Dear Dr. Blume,

We would like to thank the reviewers for constructive comments. Please find our replies below the specific comments. Our replies are marked in red, our revisions of the manuscript text are in green.

Reviewer 1

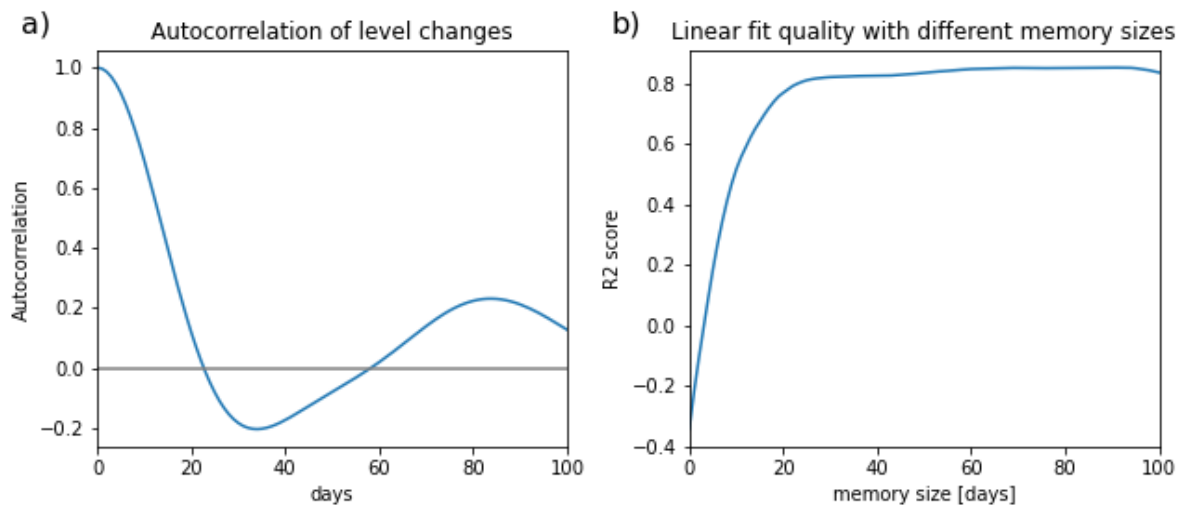
- results: there are details that belong to the methods section, in particular the applied filter to remove the annual signal requires more details; as is, this part is not reproducible; how does the signal look like after the annual signal removal? the part on estimating optimal memory should have a reference

We have added more details to the methods (see our earlier reply). The signal with the annual cycle removed is only used to generate this single figure (Fig. 3a), we have added a supplementary figure to show the modified signal.

L261 “The k-lag autocorrelation shows the time dependence of the lake level data, and give a good indication of the ideal memory timeframe for the modeling (Seeboonruang 2015).”
